Access Compliance Report

Public Rights-of-Way

(Curb Ramps)

Intersection ID: 29678	Main Street: CAMERON_CREEK_DR	Cross Street: WEDDINGTON_RIDGE_LN	Location:	N
ADA ID: 1CCA632CD921	Ramp Type: Perp	Initial Pass/Fail: Pass	Overall Compliance: No	Severity Score: 15

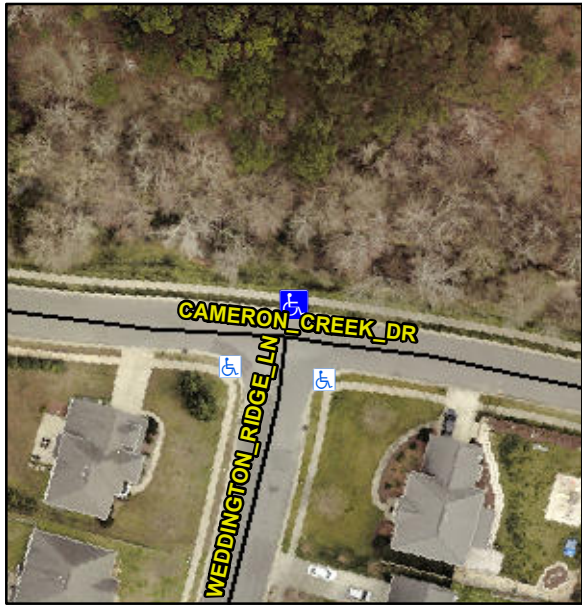
Codes/Mitigation Info/Possible Solution			Field Measurements/Component Compliance					
	Possible Solutions:		Compliance	Description	Data	Compliance	Description	Data
	Remove & Replace Entire Ramp.		N/A	Ramp Length (in)	48.0	Yes	Ramp Slope (%)	5.6
	Remove & Replace Gutter.		Yes	Ramp Width (in)	51.0	Yes	Ramp XSlope (%)	0.3
			N/A	Flare Type LT	Sloped	N/A	Flare Type RT	N/A
			N/A	Flare Slope LT (%)	4.1	Yes	Flare Slope RT (%)	1.9
			N/A	Flare Traversable LT?	Yes	N/A	Flare Traversable RT?	Yes
			Yes	Landing Length (in)	48.0	No	DWS Provided?	No
			Yes	Landing Width (in)	51.0	N/A	DWS Contrast?	No
			No	Landing Slope (%)	5.4	N/A	DWS Length (in)	N/A
			No	Landing X Slope (%)	2.3	N/A	DWS Full Width?	No
Surveyor Notes:		N/A	N/A	Landing Curb? (Y/N)	No	N/A	DWS Offset (in)	N/A
PROW/ADA:		R304.2.2-Perp, R304.3.2-Para, R304.5.3, R305, R304.5.4	N/A	Shared Landing?	No			
			Yes	Gutter Ponding?	No	No	Gutter Slope (%)	9.9

Yes	Gutter Lip Ht (in)	0.0	Yes	Gutter X Slope (%)	1.7
			N/A	Painted X Walk1?	No	N/A	Painted X Walk2?	N/A
				X Walk 1 Direction	To S		X Walk 2 Direction	N/A
			N/A	X Walk 1 Width (in)	N/A	N/A	X Walk 2 Width (in)	N/A
				X Walk 1 Slope (%)	4.0		X Walk 2 Slope (%)	N/A
				X Walk 1 X Slope (%)	1.3		X Walk 2 X Slope (%)	N/A
			N/A	Ramp inside XWalk1?	N/A	N/A	Ramp inside XWalk2?	N/A
				Road Slope (%)	N/A	N/A	Clear Space?	Yes
				Road X Slope (%)	N/A	N/A	Clear Space to XWalk (in)	N/A
			Yes	Any Obstructions?	No	Yes	Storm Grate/Utility Hazard?	No
				Obstruction Type			Storm Grate/Utility Type	
						N/A		N/A
						Yes	Surface Condition? (G/P)	Good
Total Cost:		\$ 2600.00
